July 30, 2003
LIC-03-0100

SUBJECT: Response to Request for Additional Information - Ft. Calhoun Station Steam Generator Report (TAC No. MB6954)

**Response to NRC Request for Additional Information
Ft. Calhoun Station Steam Generator Report**

Figure 1

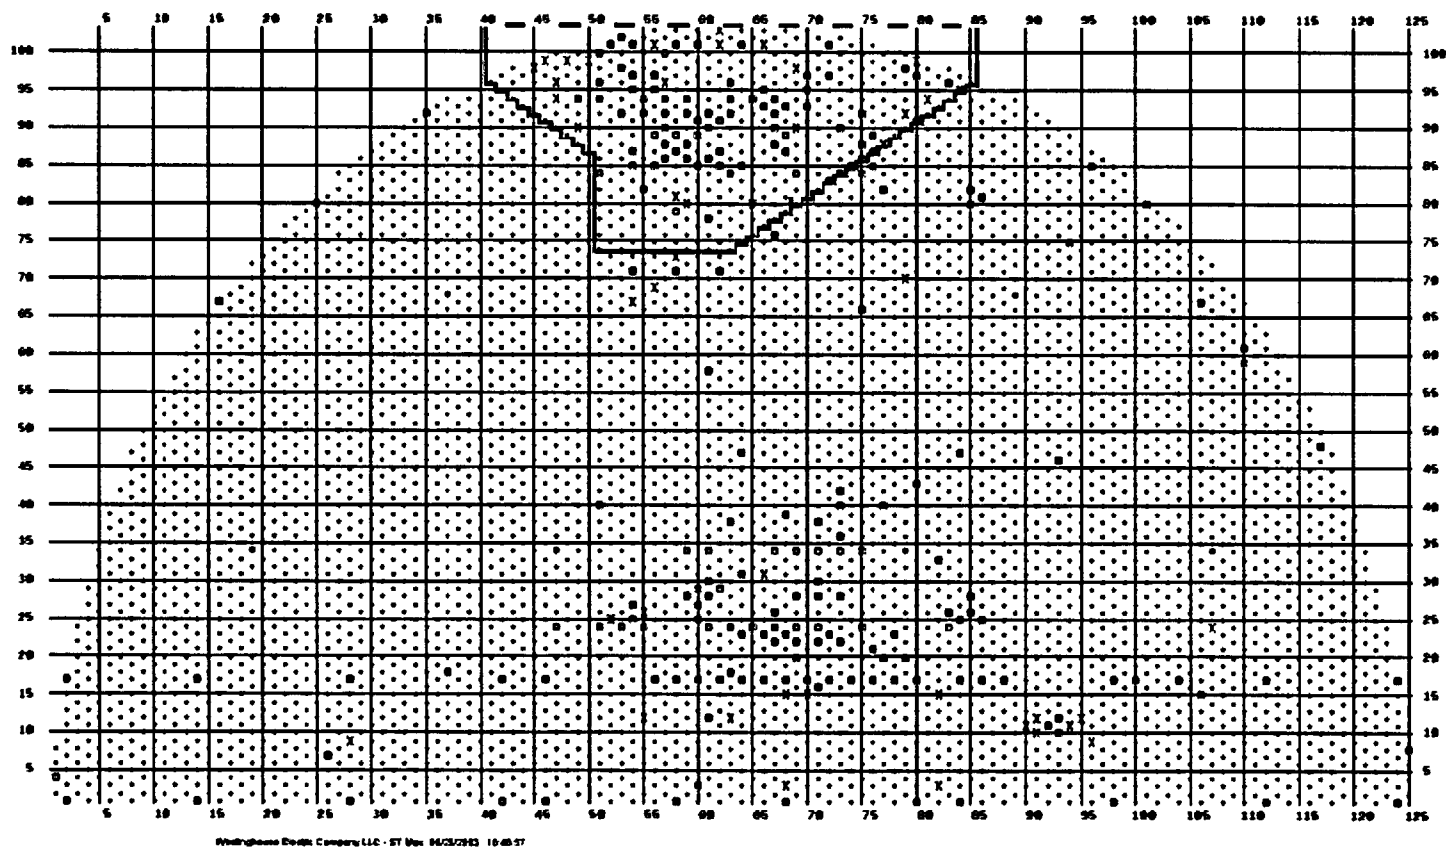
4. With respect to the MRPC examinations performed from DBH to H5 in the critical area and the MRPC examinations performed in the 90-degree bends outside the critical area, discuss the results from the examination. If flaws were identified, indicate whether the flaw was initially found during the bobbin screening (or whether the flaw was only identified with the bobbin after the MRPC results were available, or whether the flaw was only identifiable from the MRPC data). If flaws were identified, discuss whether the scope of the inspection was expanded. If not, discuss why not.

Tables 3 and 4 provide this information for all of the flaws detected in the last examination and figures 1 and 2 are tubesheet maps with the locations of flawed tubes and their proximity to the critical area. ODSCC indications were identified in the critical area which were only detected by the MRPC probe. However none of these flaws were challenging from a leakage or structural integrity perspective (the deepest was estimated at 40% TW based on plus point amplitude sizing). In addition, no degradation of the type defining the CA were observed in the buffer zone and additional program expansion was not required per the EPRI PWR Steam Generator Examination Guidelines, Revision 5.
